AGNICO EAGLE

Re: Agnico Eagle's Response to Comments on the 2024 Annual Reports for the Hope Bay Project, Project Certificate No. 003 and Project Certificate No. 009

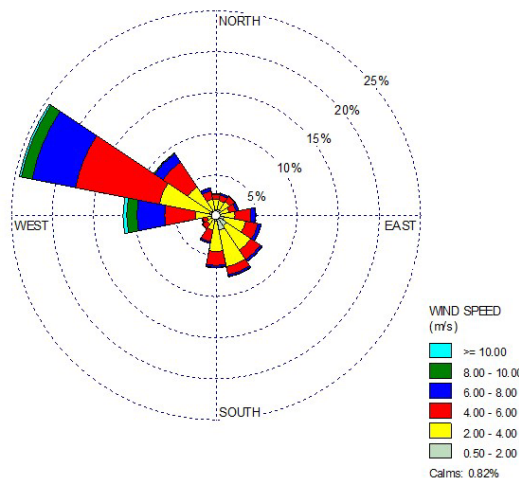
- Please clarify why stations closer to various sources (e.g. mill or quarry) were not selected or added for dustfall measurements.
- For CDF4, shifting the station 150–200 m north would make it a better indicator of dustfall originating from Quarry 2 (based on the annual windrose chart provided in the document).
- Please clarify why a specific location on the road was prioritized over other pollution sources or other sections of the road (44% of stations on Madrid sites belong to this point).

The location of DFA1 was reviewed and approved by ECCC and the NIRB in 2017. The objective of this station is to represent general Doris site air quality, not air quality within the mill/camp area. Due to its proximity to the mill in a predominantly downwind location, the measurements at this location are expected to provide a conservative representation of air quality throughout the Doris area.

The wind rose provided in Figure 4.9 of the report is noted as being for the period January to September 2024 and is not an annual wind rose, thus is not suitable for assessing the location of CDF4.

When a multi-year wind rose is considered (see image below), the predominant wind direction is west-northwesterly as opposed to the westerly direction seen in Figure 4.9. For the wind directionality seen in the wind rose below, CDF1 is well located to measure dustfall from the southerly to northerly extents of Quarry 2.

Active Wildfires on August 6, 2024

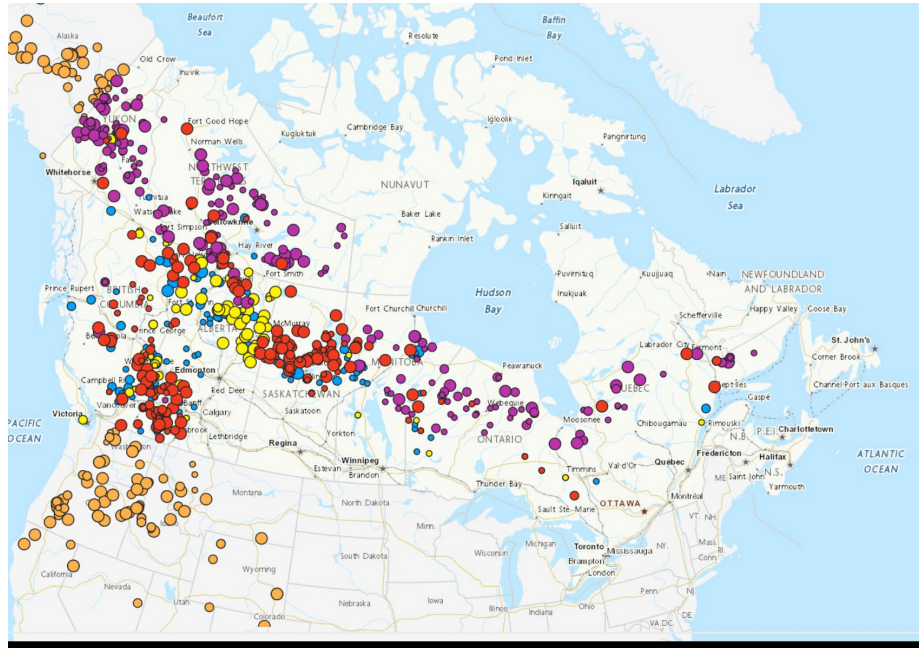
- *Please conduct a more detailed analysis before attributing high pollutant concentrations to fires located approximately 500 km from the site.*
- *Please define the “expected range of variability” for the dispersion model and demonstrate that the observed exceedance falls within that range.*
- *Please provide wind direction and fire data for the day before and the day after August 9th.*

A figure showing the active wildfires on August 6, 2024 is provided below, as long-range transport of wildfire emissions could take up to several days to travel over the distances involved. As seen in this figure, the active wildfires are very similar to those on August 9, 2024 (Figure 4.3 of the Q1-Q3 2024 report), as would be expected since the vast majority of these fires were in remote locations and uncontrolled.

The discussion in Section 4.3.1 focuses on the day of the maximum measured daily average TSP concentration, but as can be seen in Figure 4.4 of the Q1-Q3 2024 report, elevated daily average TSP concentrations were also measured in the days preceding and subsequent to August 9, 2024. The discussion in this section does not state that wildfires were only affecting the ambient measurements on a single day.

Interested Party:	KitIA	Rec No.:	KitIA-NIRB-12
Re:	Monthly Wind Rose Charts

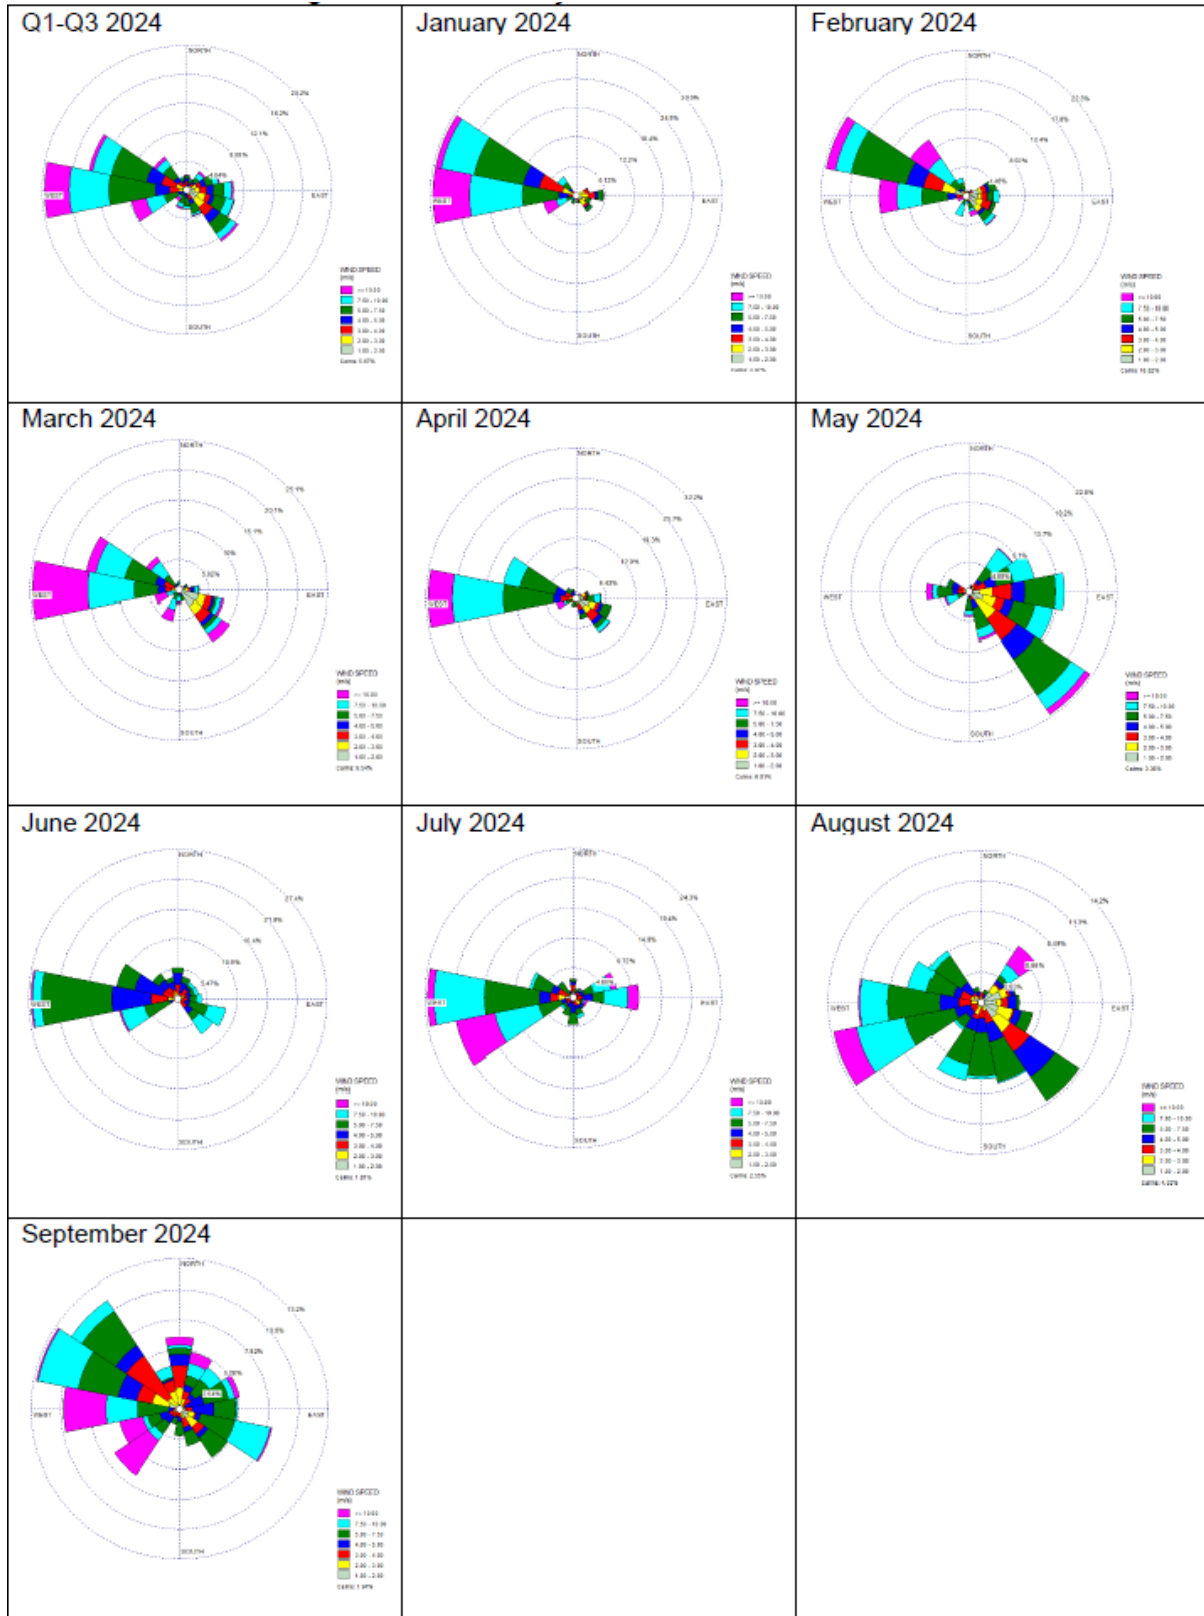
- *Please provide monthly wind-rose charts. Because the analyses are carried out on a monthly temporal scale, the results should be reviewed with wind-roses prepared at the same scale.*

The wind rose in Figure 4.9 is noted as being for the period of January to September 2024, which is the monitoring period presented in the report and is not an annual wind rose.

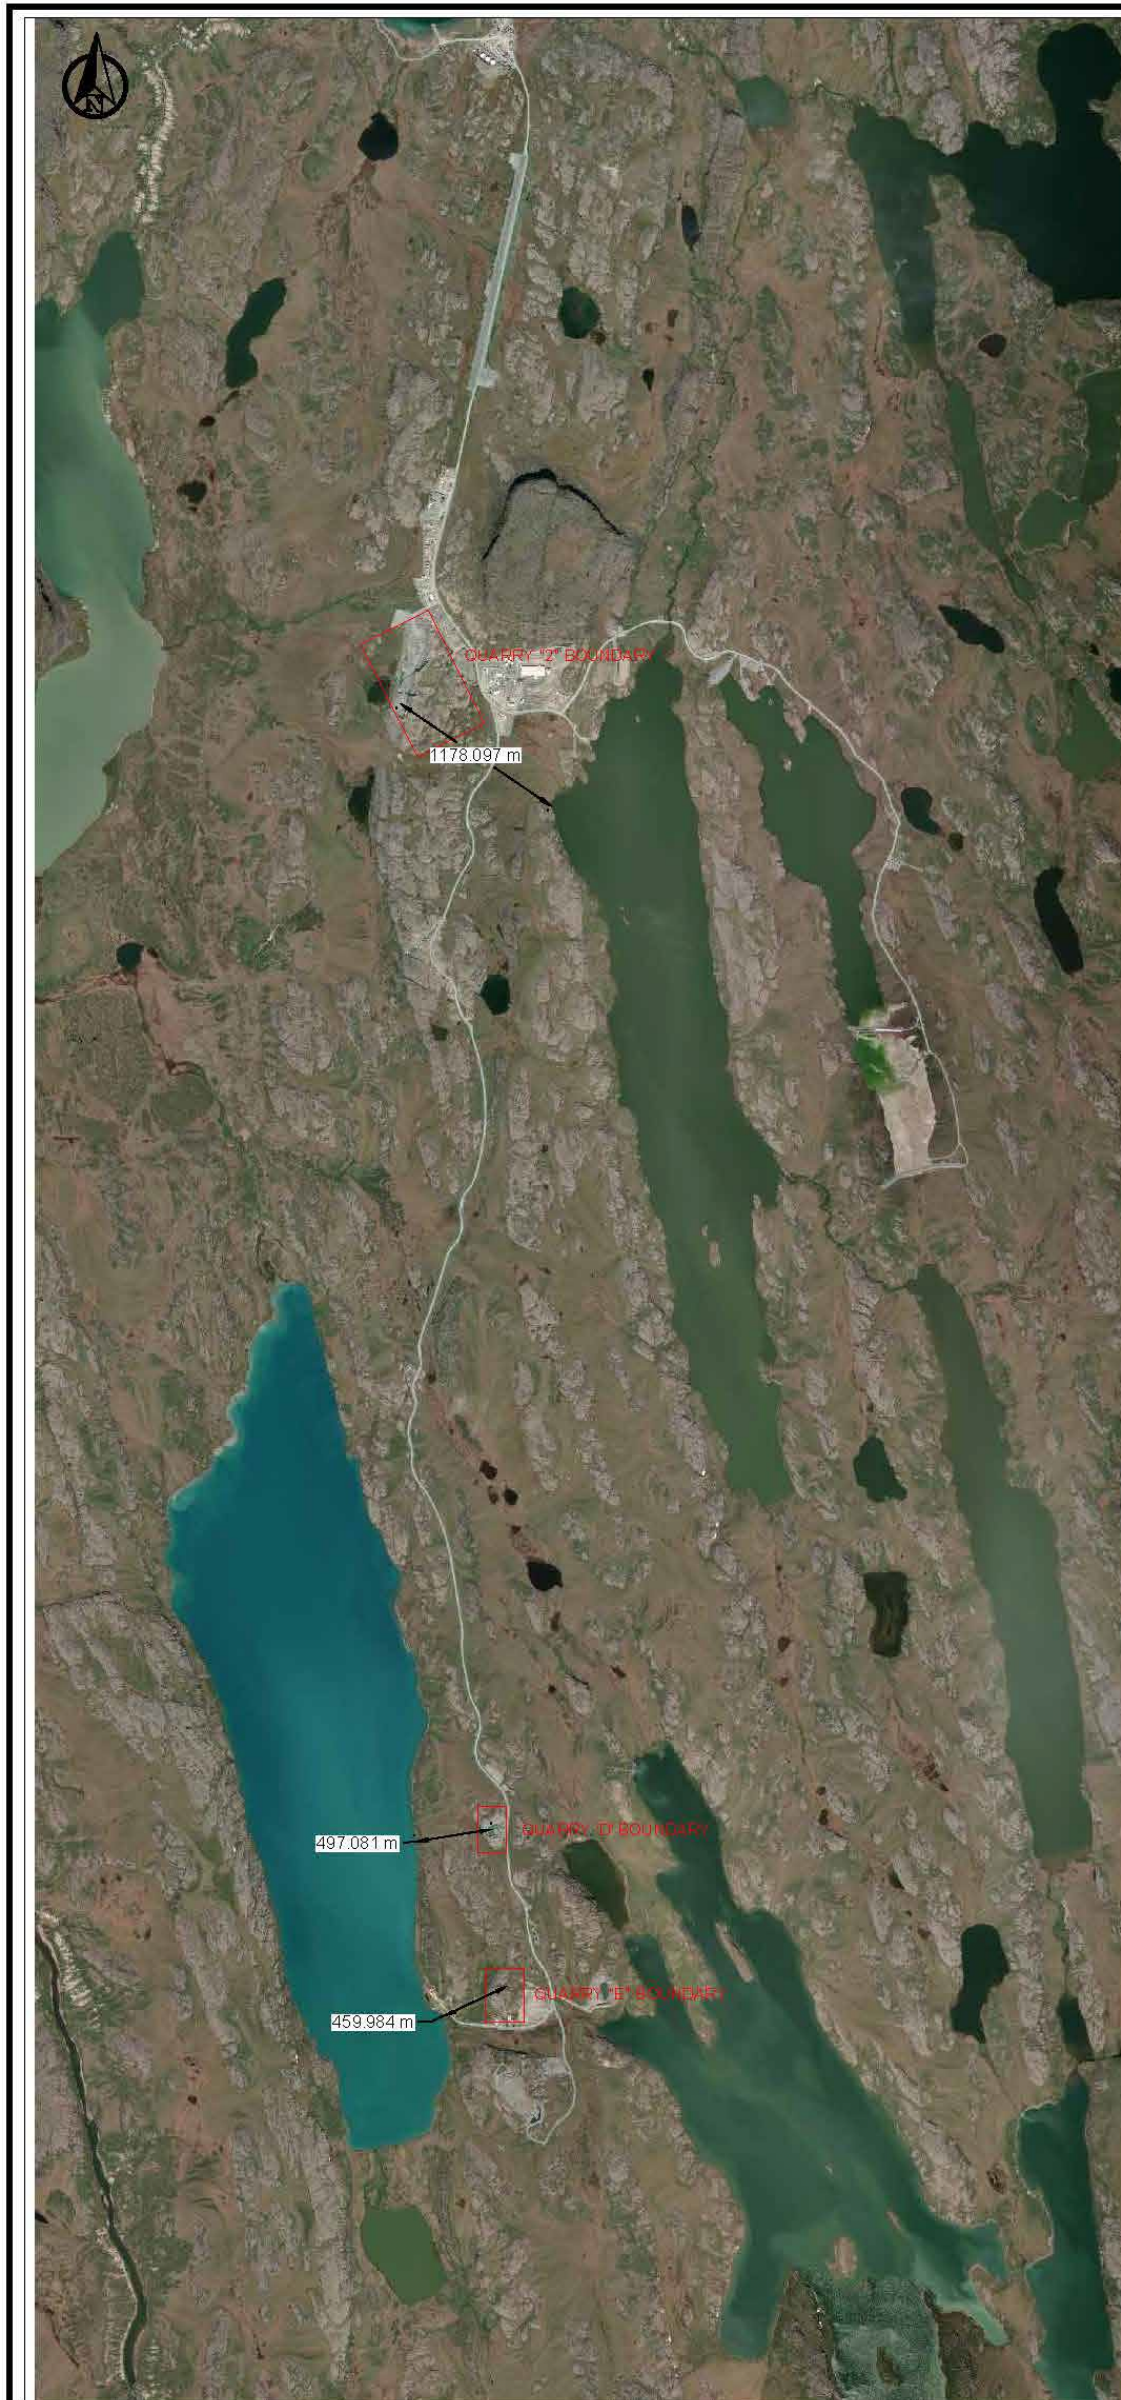
Include a summary map where the blasting occurred and distances to nearby water in the Wildlife Mitigation and Monitoring Plan (WMMP), along with proposed noise abatement measures for fish.
